STATE BOARD OF HEALTH

OFFICE MEMORANDUM

SUBJECT: Soil Borings and Observations
at Gary Land Development, Lake County

Fig 1

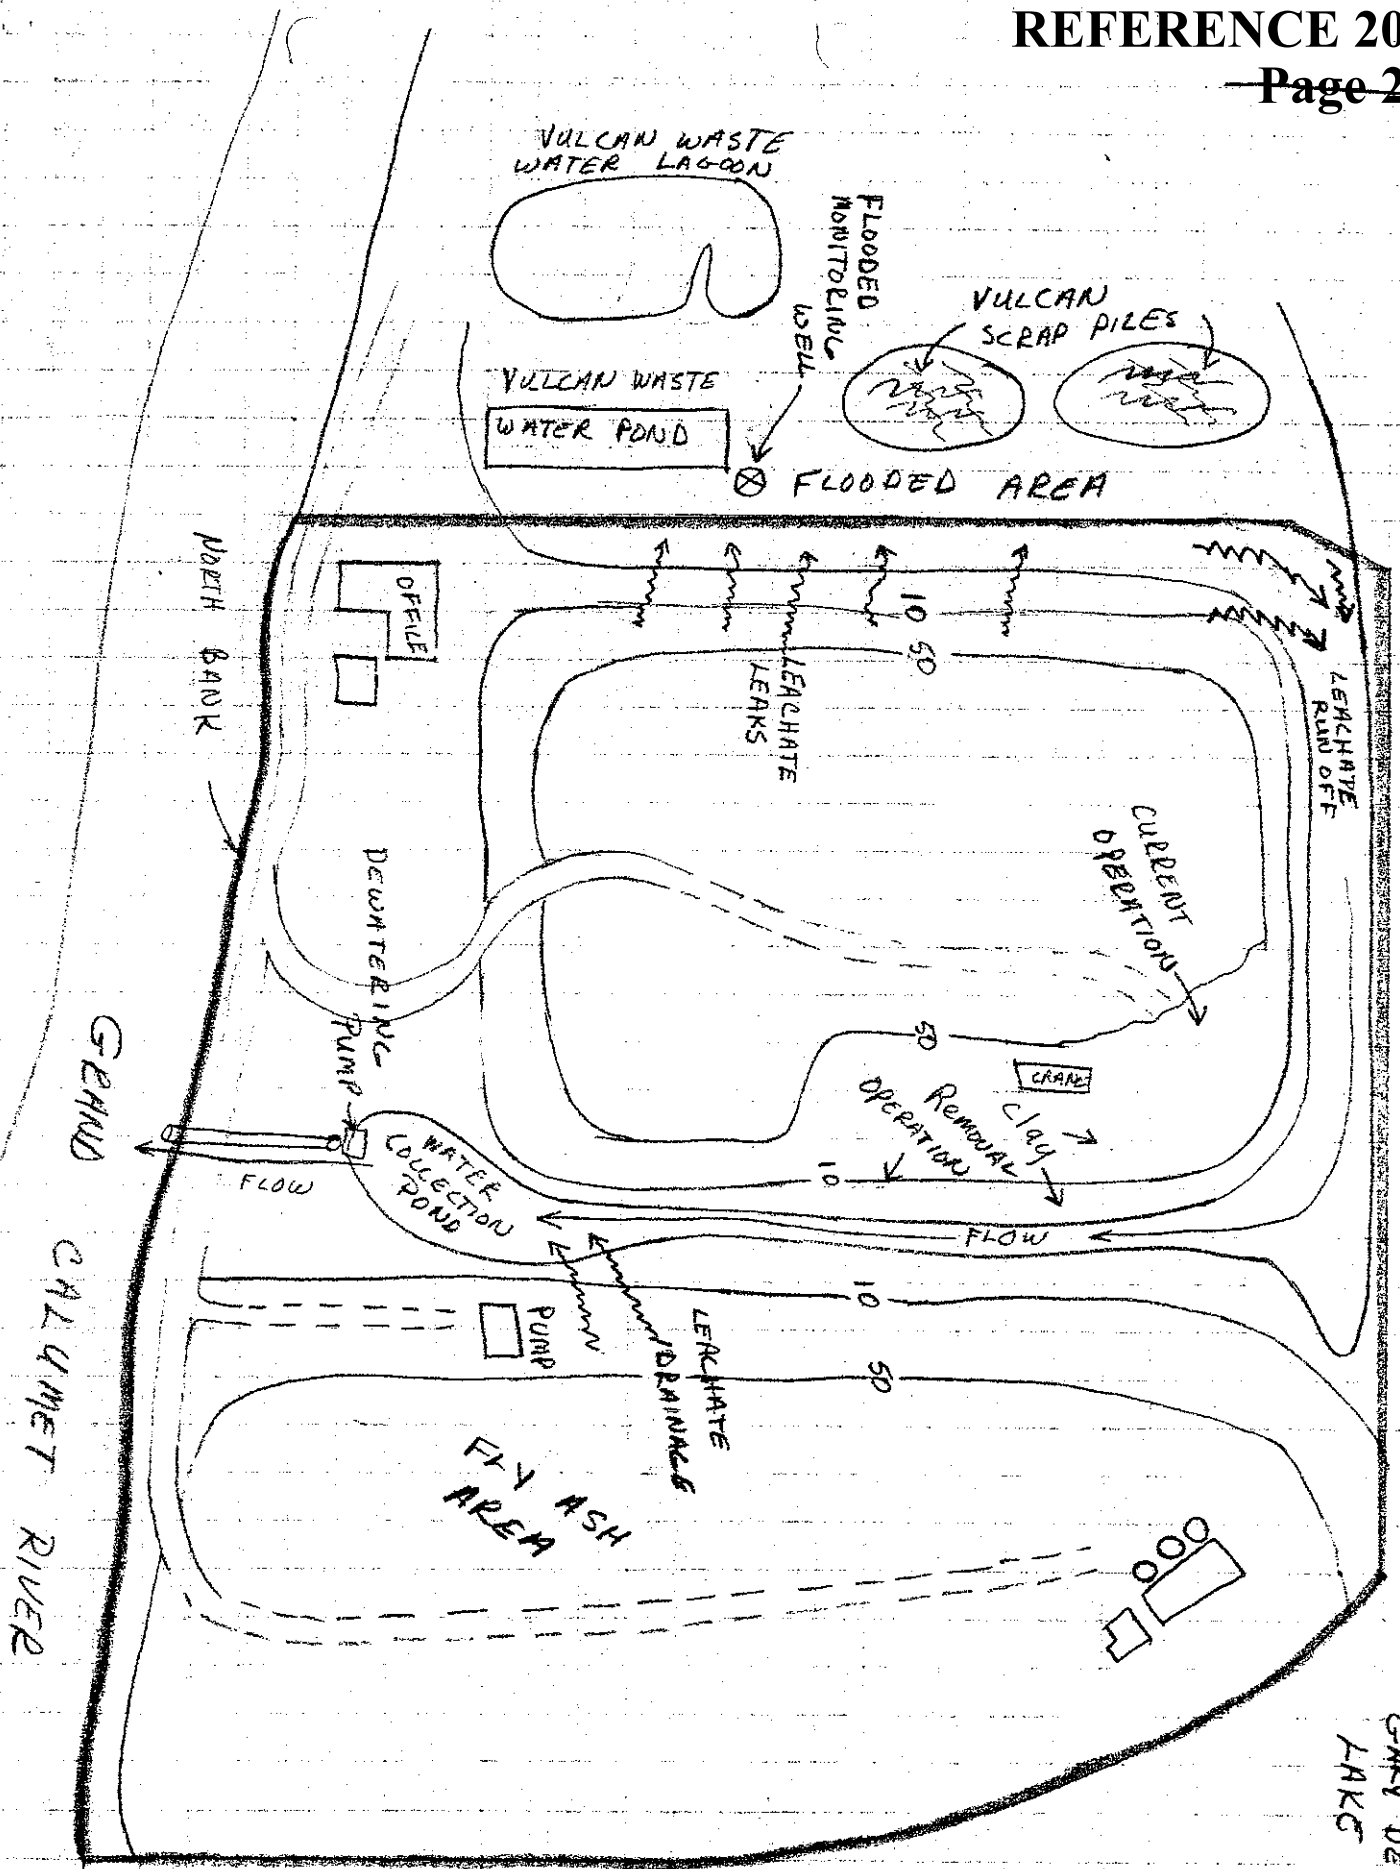
On December 16, 1985, Messrs. Duane Leith, Steve Schaefer, and I visited Gary Land Development. We walked the entire site and observed many leachate leaks. The west wall had several small leachate leaks which drained into a flooded ditch between Gary Land Development and Vulcan Recycling Company. The leaks occurred in the wall where proper clay thickness was in question. The responsible party, Mr. Larry Hagen, claimed to have six to ten feet of clay. However, their soil borings through the west wall indicate only two and one-half feet of clay. The soil boring conditions have not been met according to the court order. Additional information is needed concerning soil boring logs and testing results. The monitoring well on the west side was under water and needs to be raised or have the water drained away. It is not usable left as it is. (See diagram.)

Outside the north wall between the landfill and the railroad tracks is more drainage runoff which may be from the Vulcan Recycling Company, but runs onto the Gary Land Development property. This drainage may contain some chemical parameters that are toxic or above standard (as the monitoring well samples are). A drainage ditch bisects the landfill site and appears to be pumped into the Grand Calumet River. Per a phone conversation between Duane Leith and Joseph Krieger of Water Pollution Control on January 7, 1986, they do not have a permit. There is also leachate rapidly flowing into the ditch from the eastern bank. (See diagram.) I recommend leachate samples be taken around the site and from the drainage ditch which appears to have some oily film on the water.
